# Cabarita Beach Mixed Use Development Modification 6

Cabarita Beach Mixed Use Development Modification 6  
Assessment Report  
State Significant Development Modification Assessment  
(MP 07\_0179 MOD 6)

February 2021

**Figure 4** Proposed Alteration to Level 1 - Courtyards previously known as the Landscape Podium

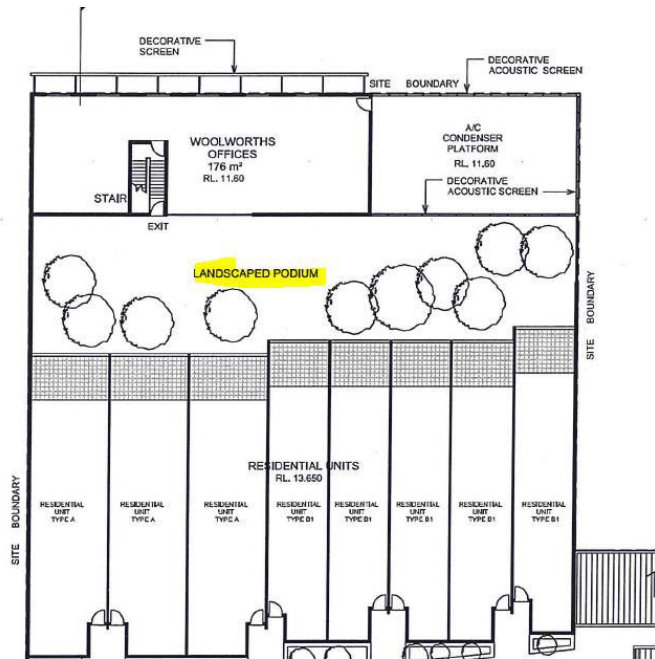
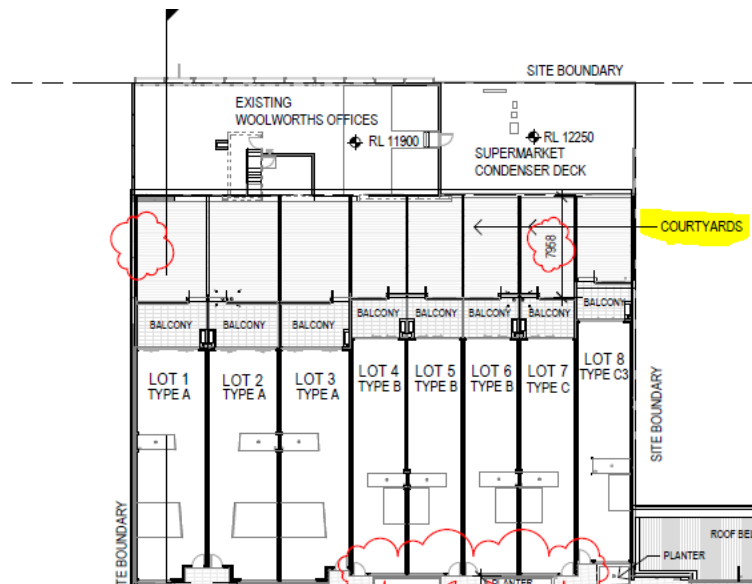
- Not supporting the reallocation of the landscaped area on Level 1 adjacent to the Hastings Road frontage to private open space for units 1-8. Council indicated a preference for this area to be used as communal open space with access for all residents.
- Proposed changes to the roof profile, with the current proposal being more monotonous and contributing little to the landscape, particularly when viewed from Hastings Road.

Public and Council submissions raised concerns about the potential impact of the proposed reallocation of landscaped open space to private open space for units 1-8 referred to as 'courtyards' on the properties on Hastings Road. The key concerns are visual enmity, noise and privacy impacts.

Council did not support this reallocation as it represents a missed opportunity for public open space and limited detail was provided in relation to the visual impact of the revised proposal when viewed from street level of Hastings Road. Council noted that it may be more appropriate to allow individual access from units 1-8 as proposed, but to retain the area as a single landscaped area which allows for access for other unit occupiers.

The Applicant has provided additional plans detailing sightlines from the neighbouring properties on Hastings Road. The plans demonstrate neither the courtyards nor the units are visible from the opposing properties. As the courtyards are not visible from surrounding properties, the Department is satisfied that utilising this area as a landscape buffer for visual amenity purposes is of minimal advantage, as it would provide no benefit to adjoining properties. Similarly, landscaping this podium will provide no benefit to privacy as there are no significant impacts in this regard.

The Department is satisfied that this proposed reallocation of space is appropriate in this case, as the space is not being used to provide any benefits to surrounding properties and will not cause

significant noise, privacy or visual amenity impacts as the space is not visible from adjoining properties.
